# 3002 SCENIC DRIVE – BOAT DOCK REPLACEMENT

SP-2020-1025D

*Watershed Protection Department*

**Rimrock/Seep**

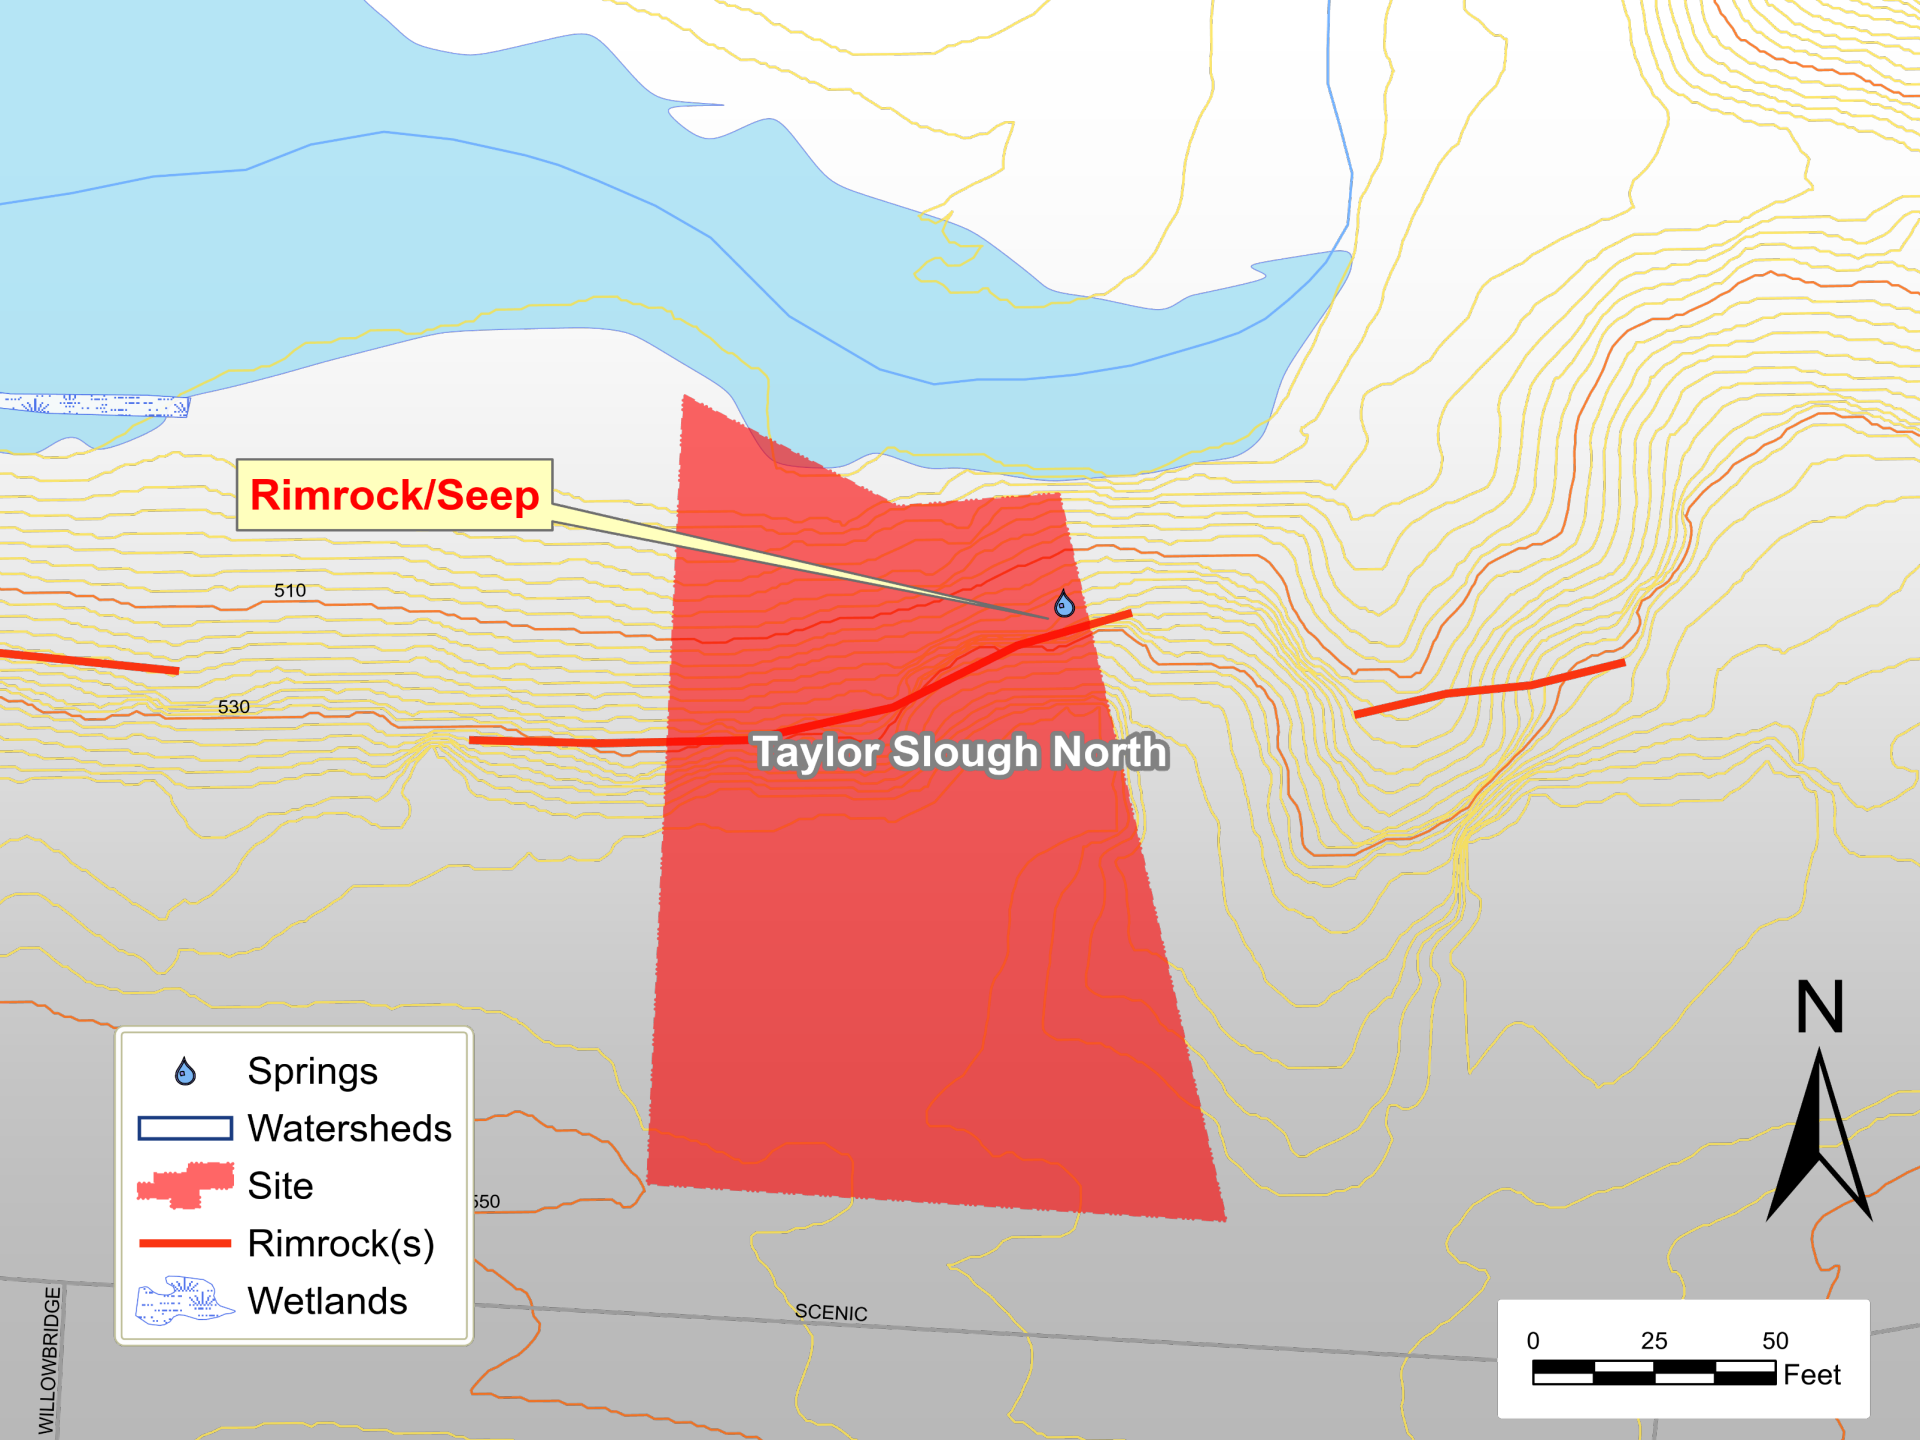
REQUEST TO VARY FROM LDC 25-8-  
281(C)(2)(B) TO ALLOW CONSTRUCTION  
WITHIN 150-FOOT OF CRITICAL  
ENVIRONMENTAL FEATURE (CEF) BUFFERS.

FINDING OF FACTS HAVE BEEN MET.

STAFF RECOMMENDS THE APPROVAL OF THIS  
VARIANCE WITH THE CONDITION THAT ALL  
CONSTRUCTION BE COMPLETED BY BARGE.
